HISTORIC AND DESIGN REVIEW COMMISSION

HDRC CASE NO: 2020-002
ADDRESS: 328 E JOSEPHINE
LEGAL DESCRIPTION: NCB 975 (BOEHLER'S SUBD), BLOCK 18 LOT 15
ZONING: C-3, RIO-2
CITY COUNCIL DIST.: 1
APPLICANT: Kristen Weber/Don B McDonald Architect
OWNER: RIO PERLA PROPERTIES LP
TYPE OF WORK: Modifications to a previously approved design regarding new construction and additions, exterior modifications
APPLICATION RECEIVED: December 20, 2019
60-DAY REVIEW: February 18, 2020
CASE MANAGER: Edward Hall
REQUEST:

The applicant is requesting a Certificate of Appropriateness for approval to modify a previously approved design regarding the relocation of an existing structure and the construction of additions to two existing structures. Within this request, the applicant has proposed the following:

1 Floor Plan - Pavilion and Bar
Scale: 1/4"=1'-0"

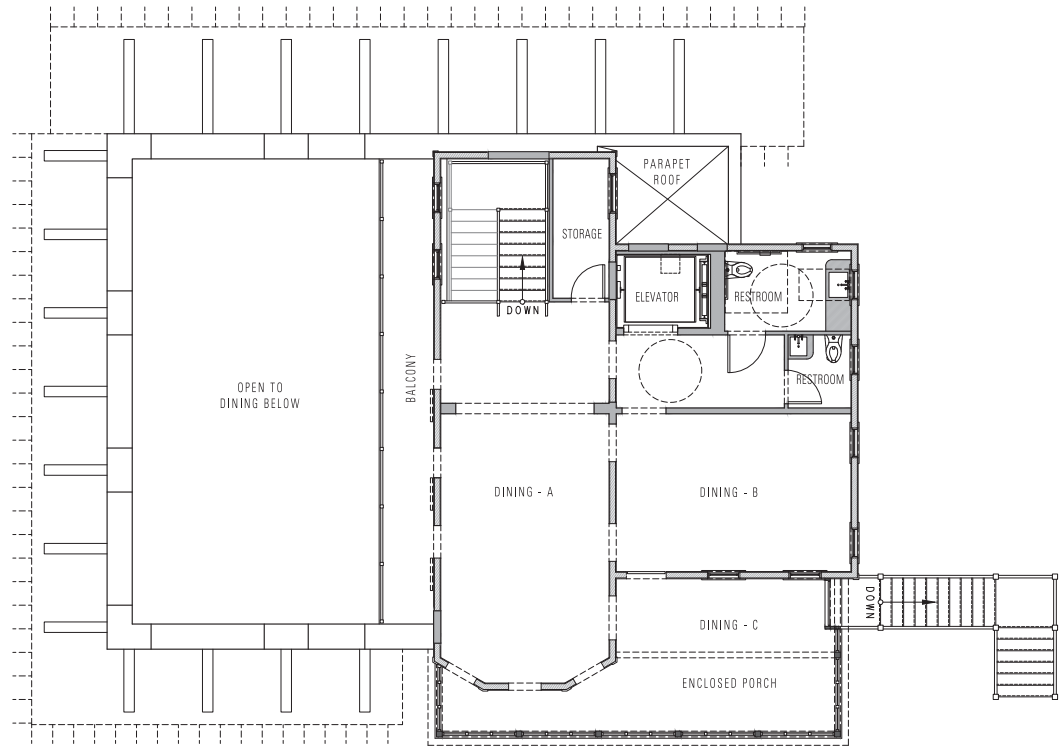
- e. **OPEN AIR PAVILION ADDITION** – The applicant has proposed to construct an open air pavilion to the north of the relocated position of the Boehler's Bar. The proposed pavilion will feature a footprint of approximately 1,066 square feet, stone rubble cladding and cast concrete lintels. The proposed pavilion will feature approximately seventeen (17) feet in height. Generally, staff finds the proposed location, massing and design of the pavilion to be appropriate. Staff finds that the porousness of the pavilion reduces its perceived massing.

1. Staff recommends approval of item #1, the modification to the previously approved design based on finding d.
2. Staff recommends approval of item #2, the construction of an open air pavilion based on finding e.
3. Staff recommends approval of item #3, the raising of the existing structure based on finding f.
4. Staff recommends approvals of item #4, the construction of a screened balcony as noted in finding g. Staff further recommends that applicant consider ways to ensure visibility of original architectural features such as reducing the amount of screening or selecting a transparent material. Any such modifications would be eligible for administratively approval.

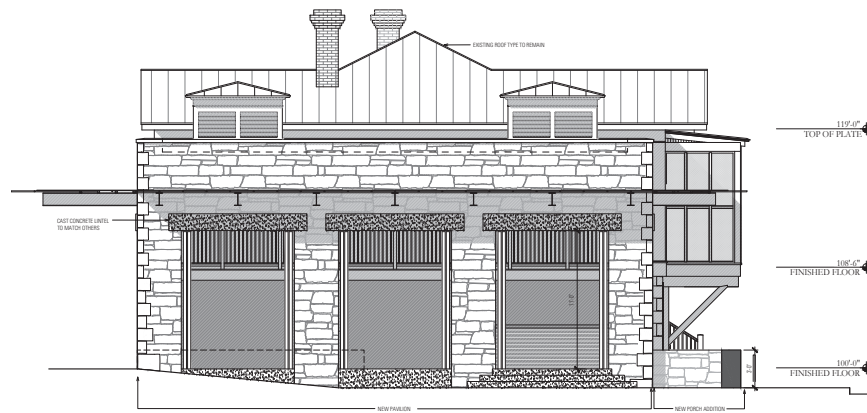
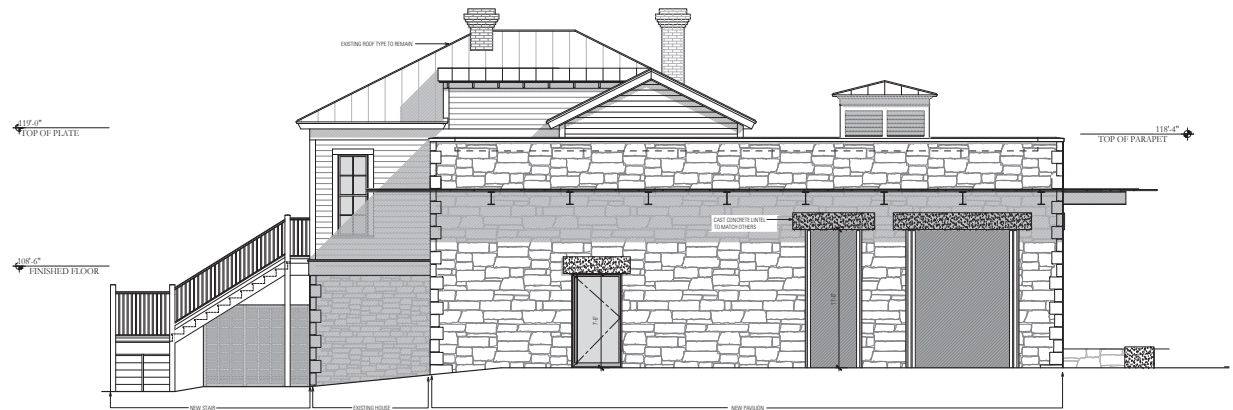
- g. **SCREENED BALCONY** – The applicant has proposed to construct a screened balcony porch on the east and west facades of the Boehler's House. The proposed balcony would be constructed in a manner that would cover the existing architectural bay on the structure's front façade. The UDC Section 35-676(b) notes that the distinguishing original qualities or characters of a building, structure, object or site and it's environment shall not be destroyed. The removal or alteration of any historic material or distinctive architectural features shall be avoided when possible. Staff finds that the addition of the screened balcony element is appropriate; however, staff finds that it should be modified to not obscure the existing bay.
